UNITED STATES PATENT AND TRADEMARK OFFICE

APPLICATION NO.	FILING DATE	FIRST NAMED INVENTOR	ATTORNEY DOCKET NO.	CONFIRMATION NO.
10/652,924	08/28/2003	Hiroyuki Koyama	03496/LH	2489
1933	7590	11/04/2005	EXAMINER	
FRISHAUF, HOLTZ, GOODMAN & CHICK, PC 220 5TH AVE FL 16 NEW YORK, NY 10001-7708			COLILLA, DANIEL JAMES	
			ART UNIT	PAPER NUMBER
			2854

Office Action Summary

DETAILED ACTION

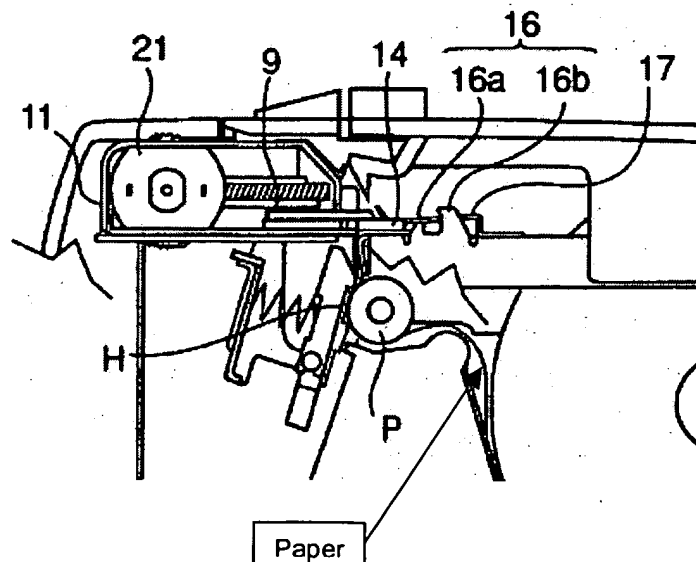
With respect to claim 1, Hosomi et al. discloses a printer unit with a guide path as shown by the paper in the Figure below taken from Figure 4 of Hosomi et al.:

Hosomi et al. further discloses a printing section having a platen P and a printhead H, a cutter section with a stationary blade 14 and a movable blade 9 with the guide path located therebetween. Figure 5 of Hosomi et al. shows a first unit located on one side of the guide path and having the platen P and the stationary blade 14 and a second unit located on the other side of the guide path having the printhead H and the movable blade 9. Hosomi et al. additionally discloses a connecting mechanism 8,12 which removably connects the first unit to the second unit.

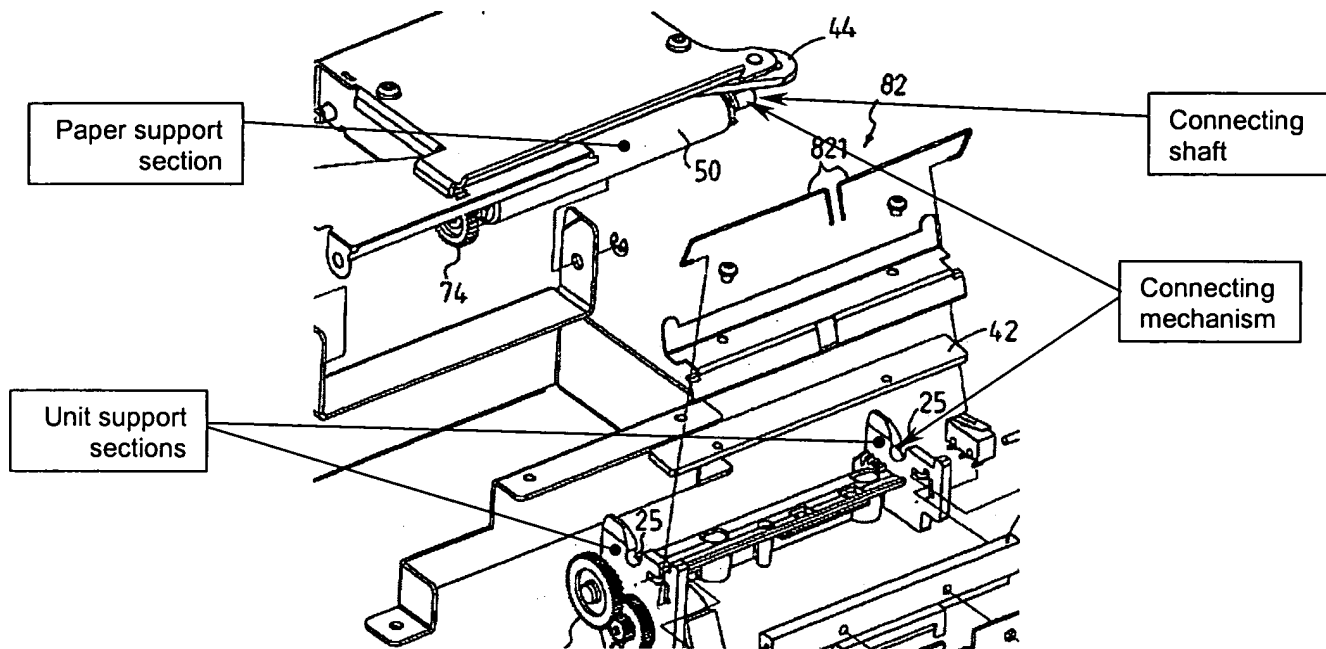
With respect to claim 2, the frame of the printer that surrounds the notch 25 is a unit support section that removably supports the first unit as shown below in the Figure taken from Figure 2 of Robinson:

With respect to claim 3, the connecting mechanism has a plurality of connecting shafts (only one is shown in the above Figure) mounted in the first unit, the axes of which are orthogonal to the direction of the guide path of the paper, and a plurality of support sections provided in the second unit for fitting the connecting shafts.

With respect to claim 4, the platen 50 has a paper support section and a support shaft at either end of the paper support section to serve as one of the connecting shafts as shown in the above Figure.
